**OceanView at Cumberland, Tuttle Road, Cumberland
Revised Preliminary Subdivision Plan Submittal –*ADDENDA-1A*
(Map R04 Parcels 4B, 4D, 4E and 5)**

Subject: Peer Review of OceanView At Cumberland
Major Subdivision and Site Plan Application – Preliminary Review
Tuttle Road, Cumberland, Maine

Subject: Peer Review of OceanView At Cumberland
Preliminary Stormwater Review for Major Subdivision and Site Plan Application
Tuttle Road, Cumberland, Maine

Little Acres Drive PROFILE

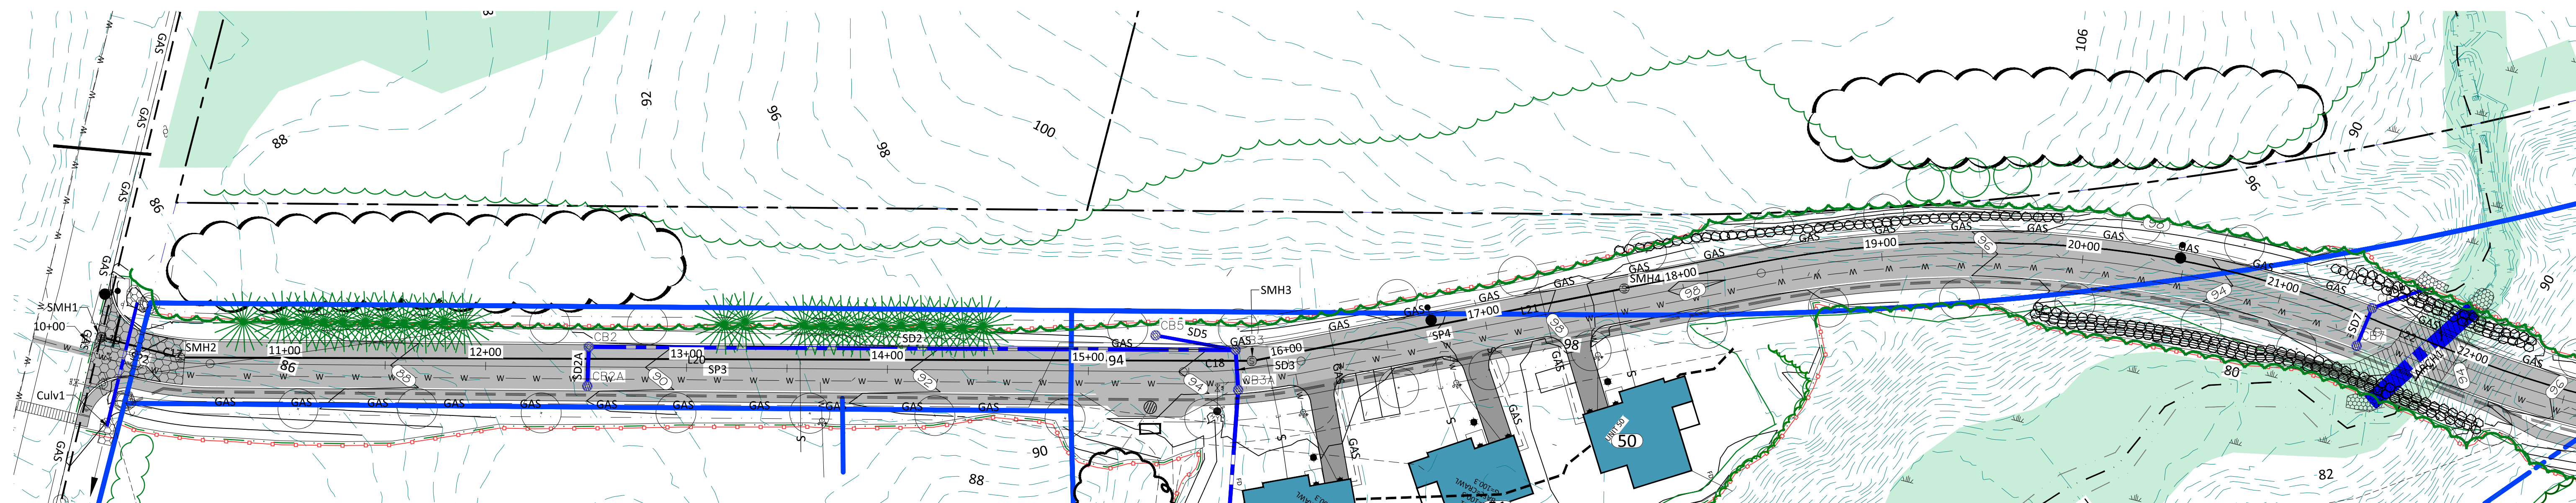
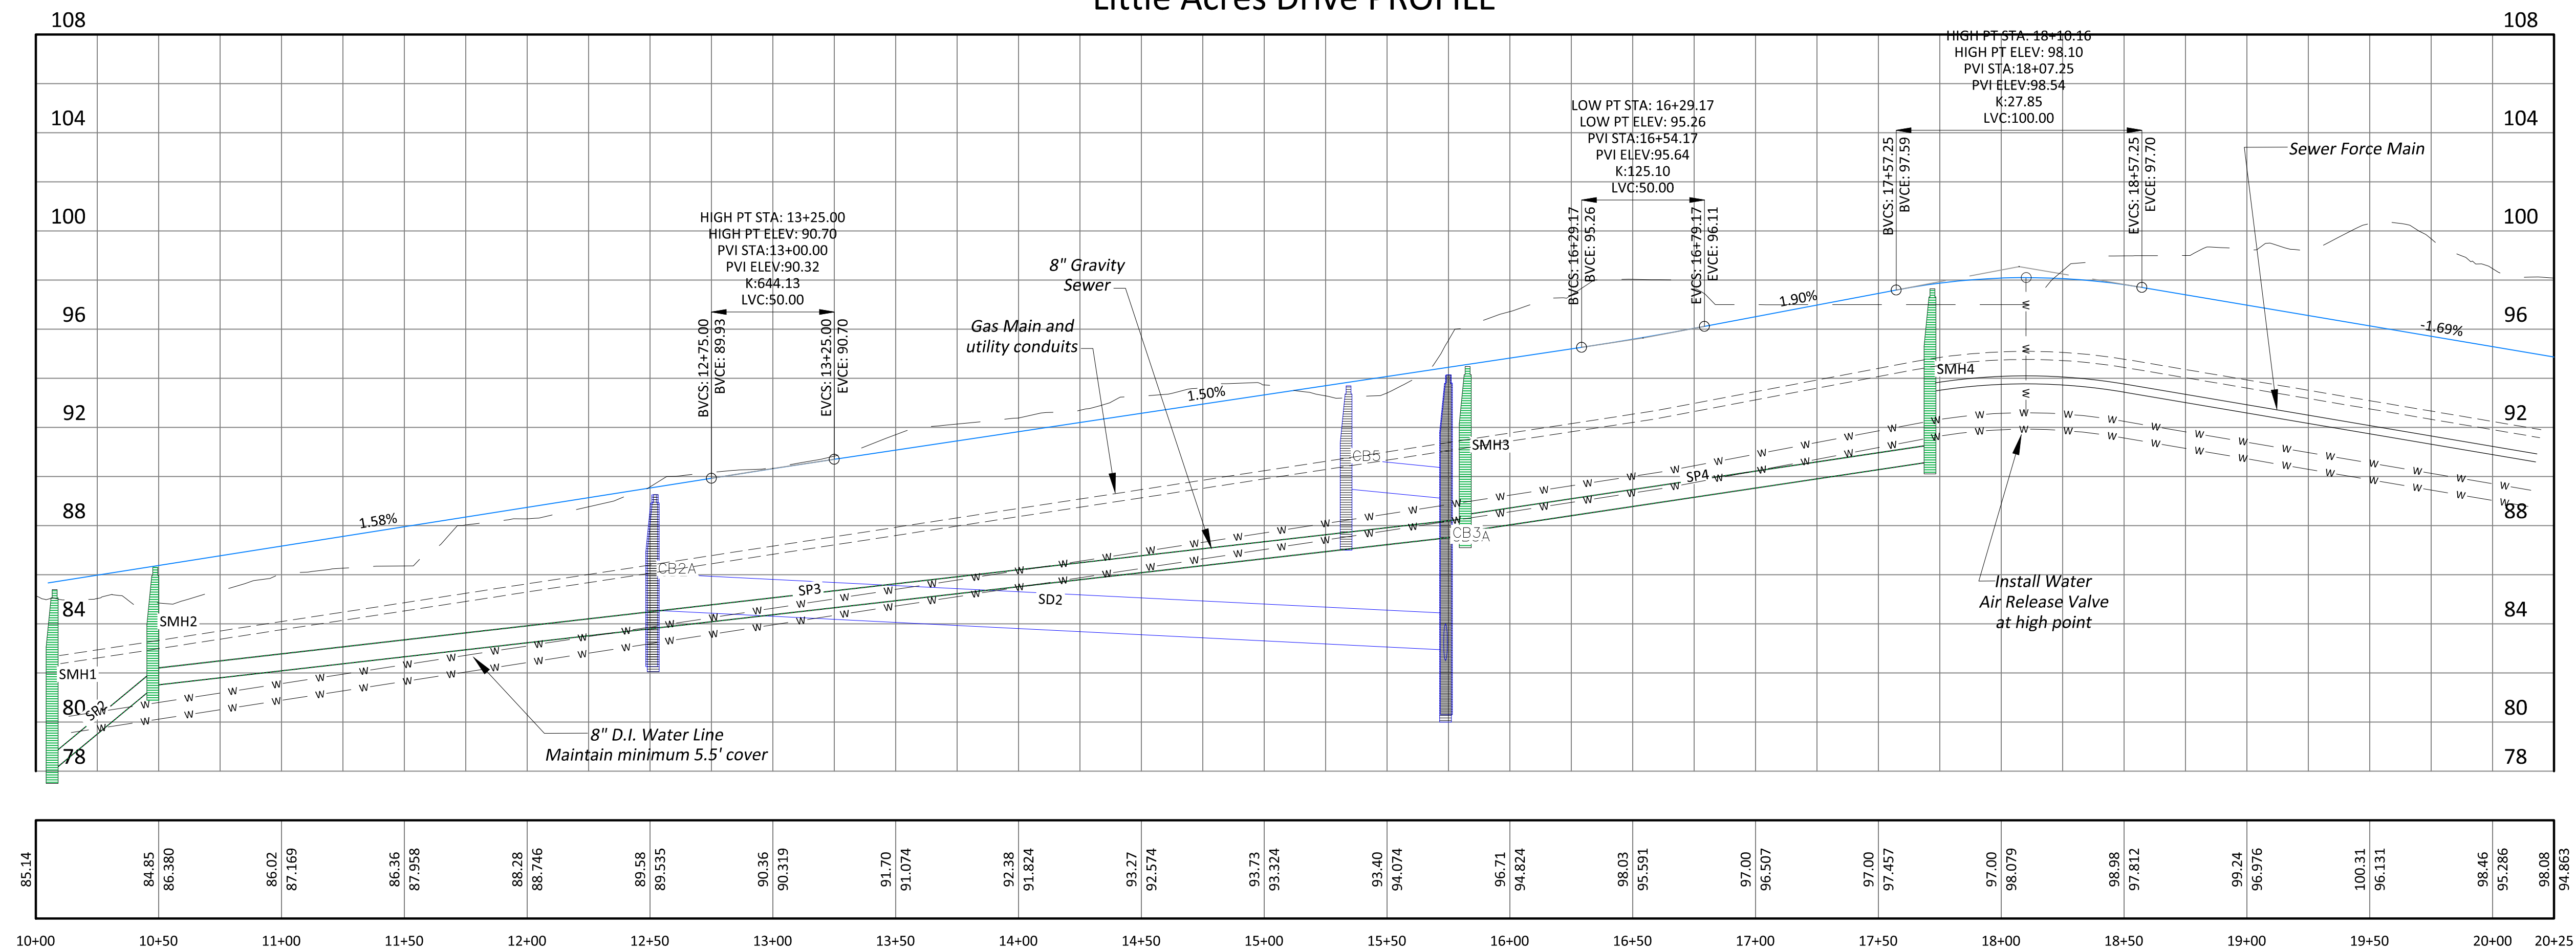
30. Plan and Profile Plan Sheets C6 through C10 do not outline utility information for force main, electric or communications wiring. SME recommends this information be added to the plan. *Utility information has been added to the Plan and Profile Sheets C6-C10.*

31. Roadway design does not conform to minimum K factors for sag vertical curves at Little Acres Drive STA 21+50; Arctic Fox Drive STA 41+99.64 and STA 44+99.90; and Arctic Fox Spur STA 21+61.63. SME recommends the applicant review these areas and adjust to meet Town construction standards. *The applicant's engineers have met and reviewed the K factors and revised the plans. The SHC Overlay Ordinance Section 315-28.4. I allows a min, K factor of 15 for crest and 20 for sag vertical curves. The profiles have been modified to meet these requirements.*
